206 E 10 St

P.D.  
ALT. No. 1823 19 54 BLOCK 451 LOT 14

## AMENDMENT

Alt. APPLICATION No. 1823 1954 BLOCK 451 LOT 14  
 (N. B., Alt., Elev., etc.)

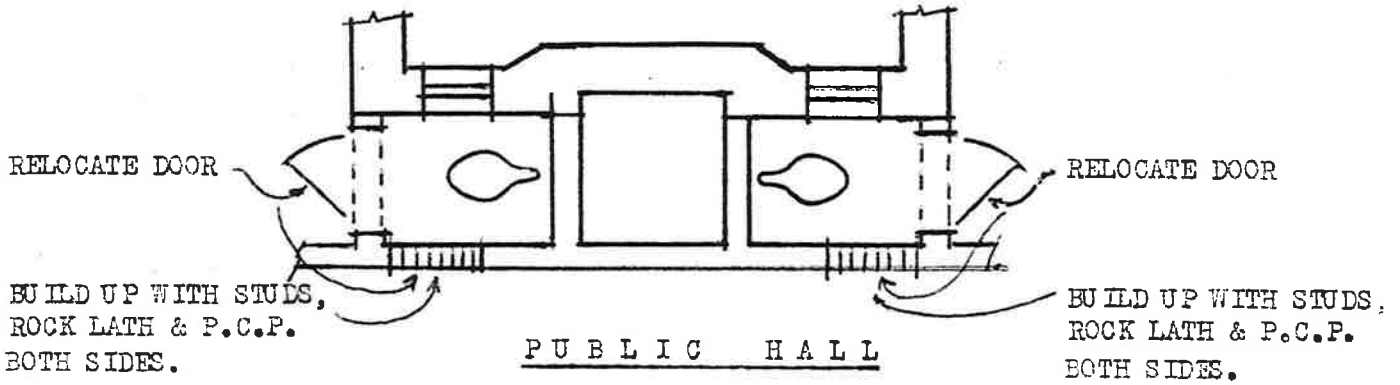
- BUILD UP DOOR OPENINGS FROM PUBLIC HALL TO TOILET ROOMS ON THE 1st, 2nd, 3rd, 4th, 5th and 6th floor. MAKE NEW OPENINGS FROM BEDROOM TO TOILET ROOM. SEE SKETCH BELOW.
